Letters to the Editor

The Author Response: A Case Study on Engineering Failure Analysis of Link Chain

Fig. 1. Boundary and loading conditions of elastic stress analysis in each installation condition. (A) Correct installation condition. (B) Incorrect installation condition.

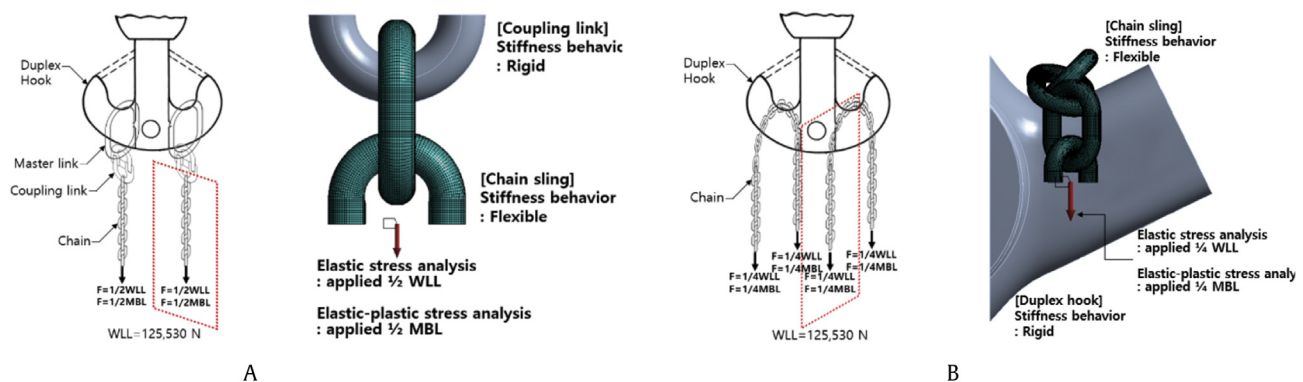
1. Response revised on FEA category in this paper: This article is written for supplementation of stress analysis parts (relatively idealised and straightforward structure, simplifying the loads and material property assumptions, etc.) for crane chain in the existing paper [1]. In material properties, an elastic material model for stress analysis, which was conducted in an existing paper, was used to re-evaluate plastic collapse due to the Working Load Limit (WLL) in each installation condition. The analysis results show that high stress (total stress) at the junction of the barrel and that of curvature of the crane chain are similar in the area where the crane chain was broken. Compared with the correct installation conditions, when high stress is applied, the incorrect installation condition evinced a breakage. For determining the membrane and bending stress components, the total stress distribution was obtained from elastic stress analysis, and linearised on stress component integrated along the cross-section of Stress Classification Lines (SCLs) through

Fig. 2. Results of elastic stress analysis of correct installation condition.

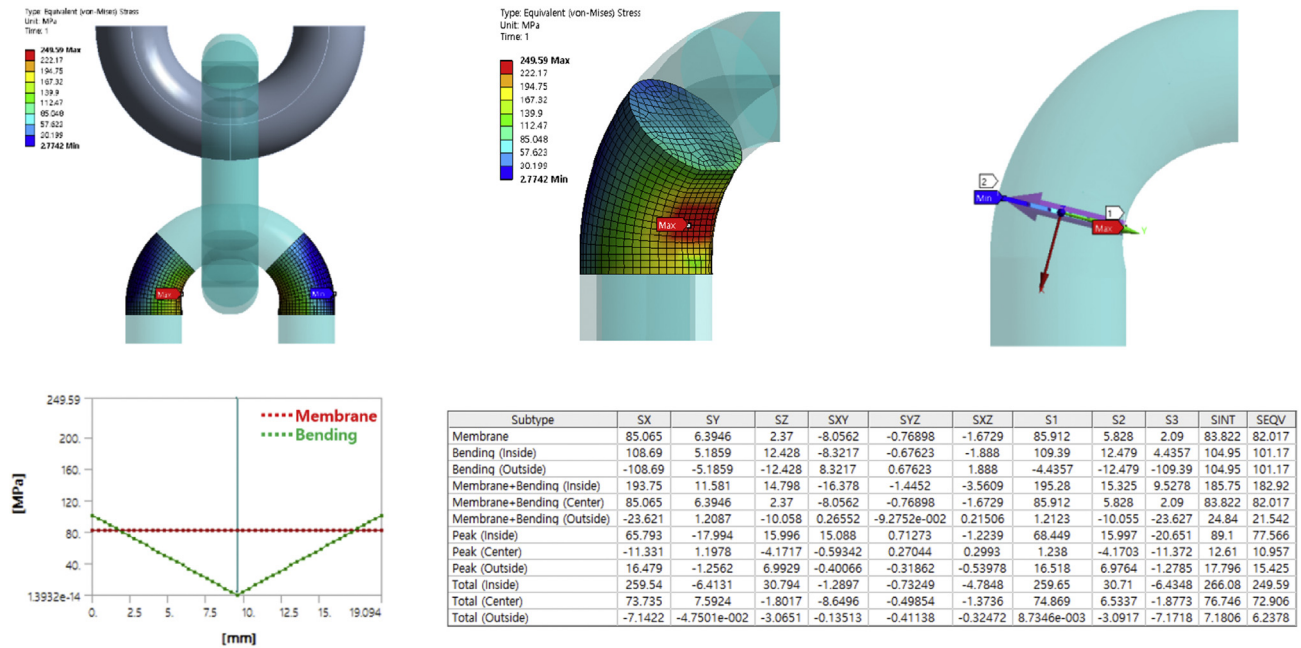
the crane chain's wall thickness. It is shown that the results of this analysis support the results of the fractographic analysis presented in the original paper.

Fig. 3. Results of elastic stress analysis of incorrect installation condition.

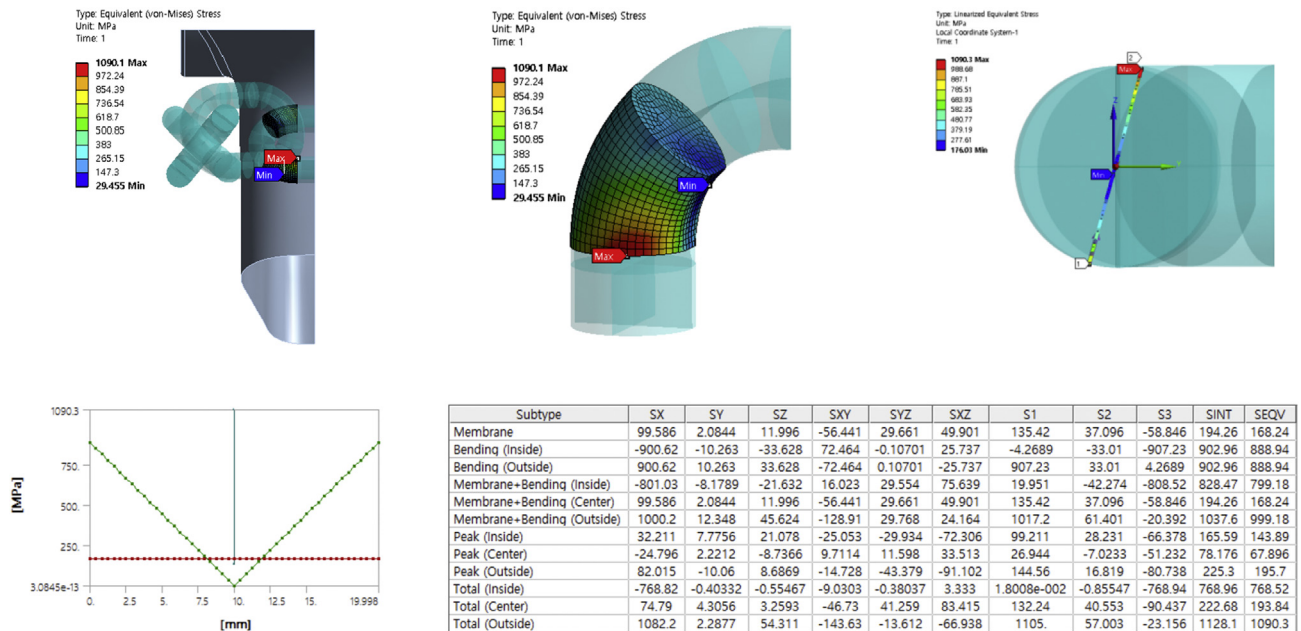
2. Additional explanation of the fractographic analysis: According to your comments on the paper, you claim that “the crack likely initiated around the chain inner surface, where the presence of high tensile stress under tension load or small stresses under bending load while a ‘crushed damage’ area was found there.” However, the crushed damage observed in the chain's inner surface cannot be formed by uniaxial tension load because the inner surface of the chain at this position was not contacted with other chains on the condition that the crane chain was installed correctly, as shown in Fig. 7 [1] A in the paper. Accordingly, we concluded that the crushed damage was possibly formed by an improperly installed crane chain inducing abnormal interlocking of the chains (Fig. 3).
